## Photodiode Transimpedance Amplifier Design Review

This document contains my notes on future improvements to my PCB-based photodiode amplifier.

## **Showcase of assembled PCB board**

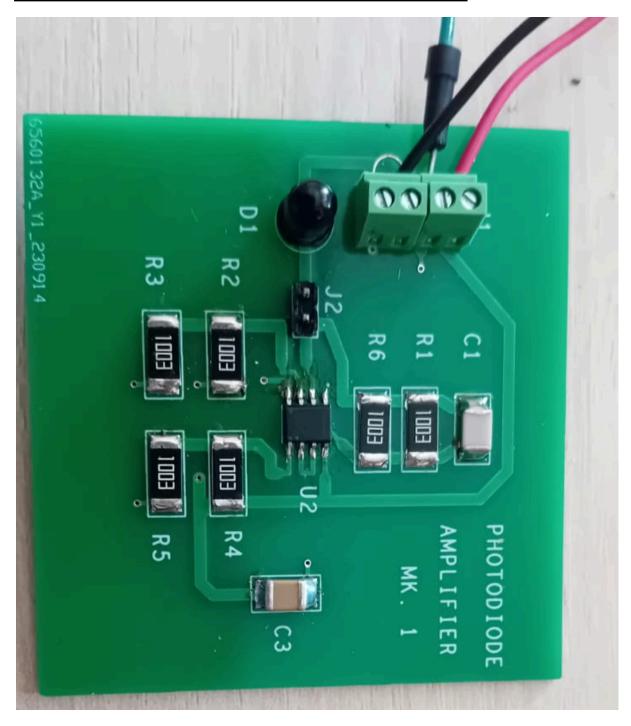
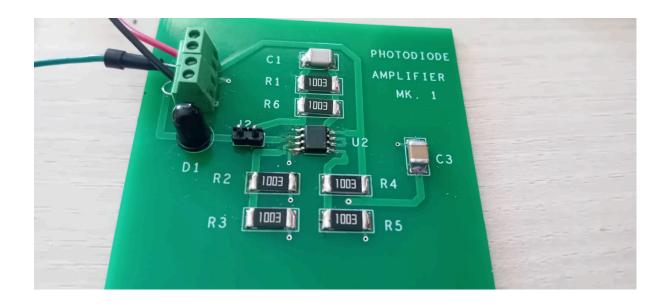
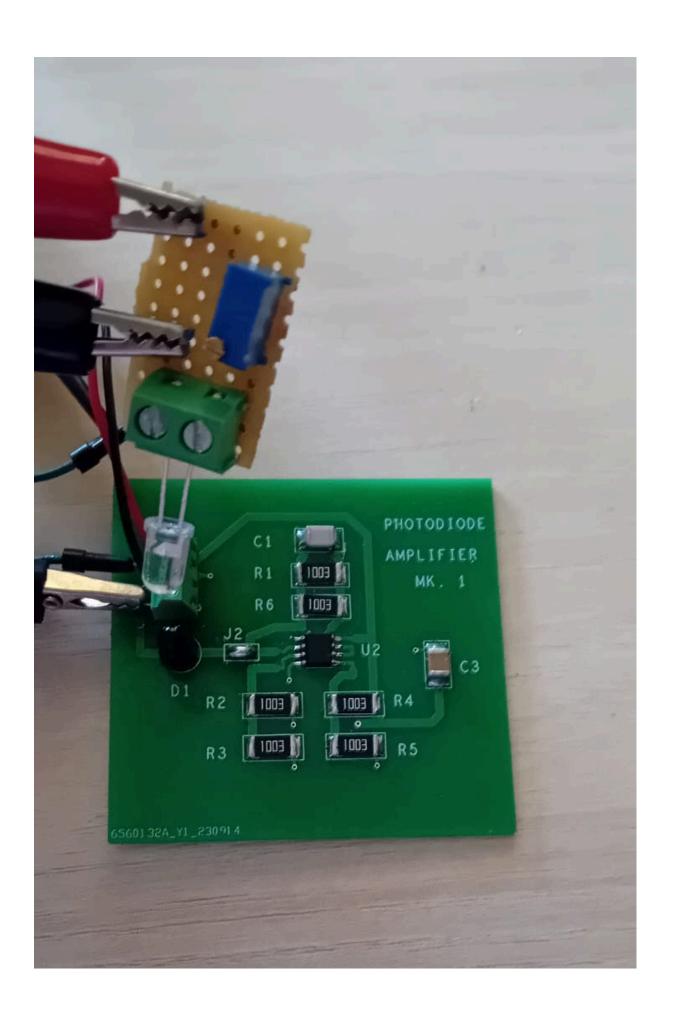
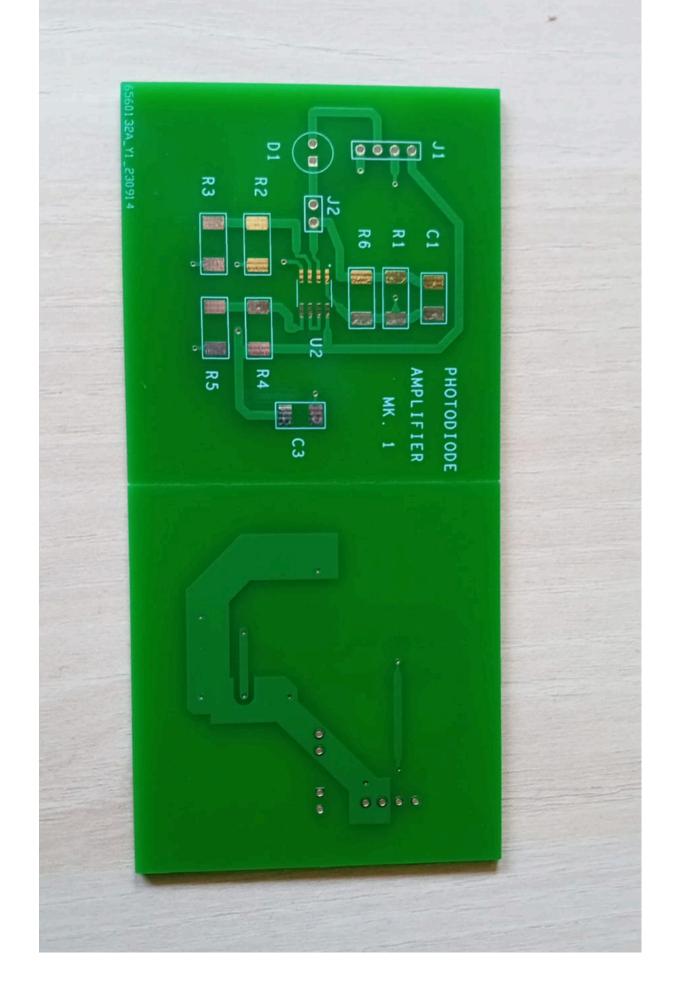
- Used two 2X 2.5mm screw terminals without lateral rails instead of 4x 2.5mm screw terminal => issues with spacing
- IR photodiode is too close to the terminals

- Terminals should be moved more to the side
- Better connector for ammeter connection: instead of 2.54mm header use something else, like a JST connector

- The PCB should be a rounded rectangle with M3.5 mounting holes at every corner
- The opamp should either be bigger or use passive components more appropriate in size to the SO8 footprint

- Except for the feedback resistor, the others should be 10K instead of 100K to not affect the stability of the circuit
- The PD is reversible and cand have and additional bias voltage, but needs to have another type of connector, because soldering and desoldering it won't work every time

- To have a better learning platform I should add more test points and a develop a IR emitter-based test fixture as well as a nano-Ampere current sensor for the PD current

- Unused second op amp should be used as a buffer for the DC offset of the main TIA
- Add 0.1uF and 1uF filter capacitors as close as possible to opamp
- Narrower traces could be used

- make single vcc plane or physically separate VCC from output signal
